# Authorized Field Change

AFC 10915

**Subject:** Turbocharger Actuators on Certain MaxxForce® DT Engines

**Figure 1 Component Locations**

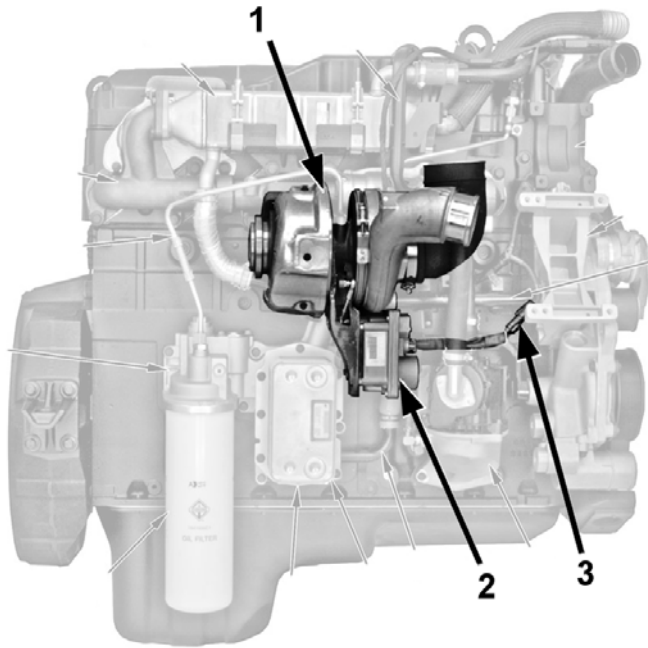
Certain vehicles listed above that were built with MaxxForce DT engines between 3/25/2010 and 4/29/2010 may experience premature failure of the turbo actuator due to insufficient internal lubrication during manufacturing.

This campaign will require the replacement of the turbo actuator.

1. Shift vehicle transmission to park or neutral, set parking brake, and install wheel chocks.
2. Raise hood assembly.
3. If vehicle's passenger side fender extension limits access to the area of the turbocharger actuator, remove it and set it aside.
4. If vehicle is equipped with a passenger side engine splash shield, remove it and set it aside.
5. Disconnect turbocharger actuator wire harness at connector (Figure 1).

9. Connect turbocharger actuator linkage to the turbocharger.
  10. Connect turbocharger actuator wire harness at connector (Figure 1) and secure with lock tab.

**Figure 2 Turbocharger Assembly Components**

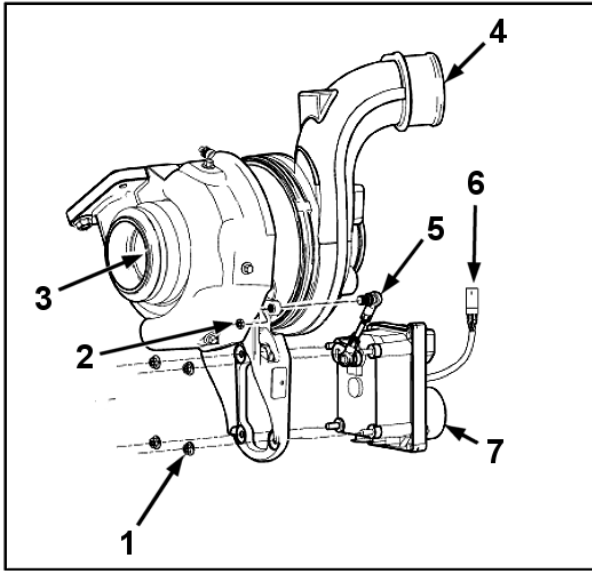
1. TURBOCHARGER
  2. TURBOCHARGER ACTUATOR
  3. ACTUATOR HARNESS CONNECTOR
- 
6. Disconnect turbocharger actuator linkage from the turbocharger (Figure 2).
  7. Remove turbocharger actuator by removing four (4) lock nuts securing actuator to mounting bracket (Figure 2). Discard the lock nuts.

7. TURBOCHARGER ACTUATOR
8. Use the four (4) lock nuts provided in the parts kit to secure the new turbocharger actuator to its mounting bracket (Figure 2). Torque to 120 lbf-in (14 N•m).
